DUNDRY NOTICES AND REPORTS ON WELLS

Yates Federal #2

Yates Petroleum Corporation plans to plug and abandon this well as follows:

WELL NAME: Yates Federal # 2 FIELD: Penasco Draw

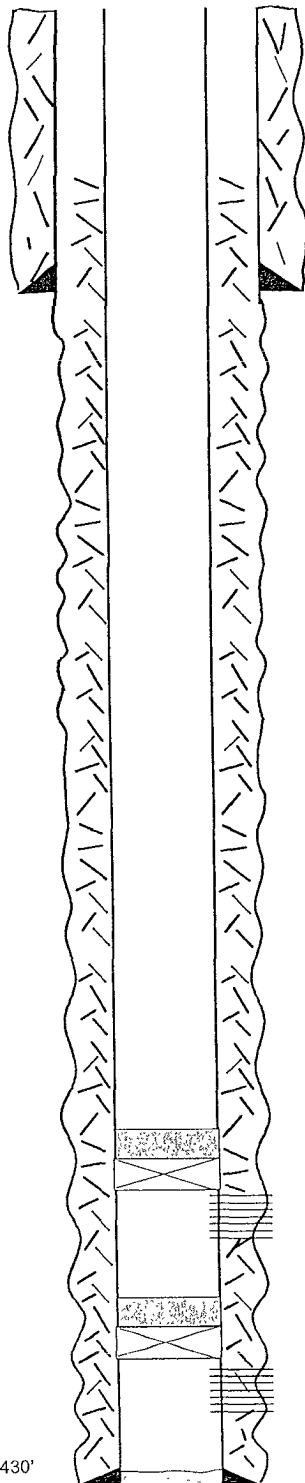
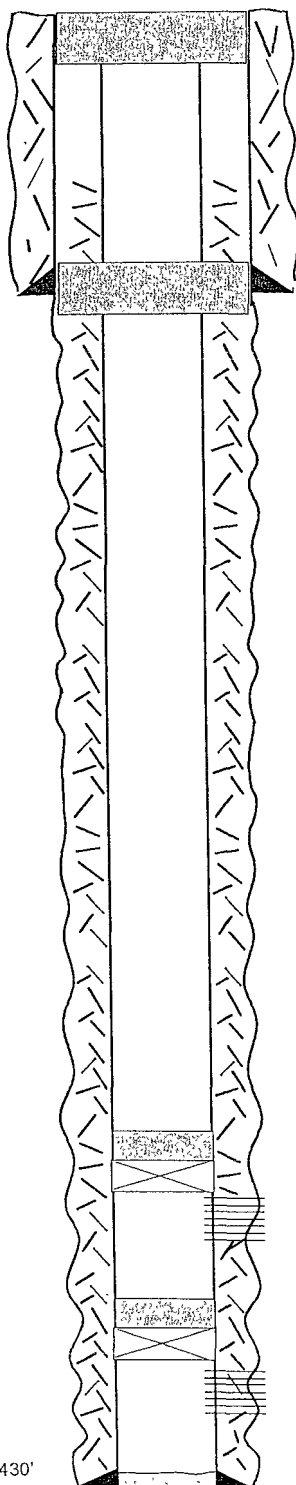
1. Perforate squeeze holes at 960'.
2. Spot a 100' cement plug from 960'-1060' (35 sx) inside and outside casing. Tag plug.
3. Perforate squeeze holes at 100'.
4. Circulated cement from 100' to surface with 35 sx cement. Tag plug.
5. Cut off wellhead and install dry hole marker and clean location as per regulated.

100' cement plug 0' - 100' (Tag Plug)

100' cement plug 960' - 1060' (Tag Plug)
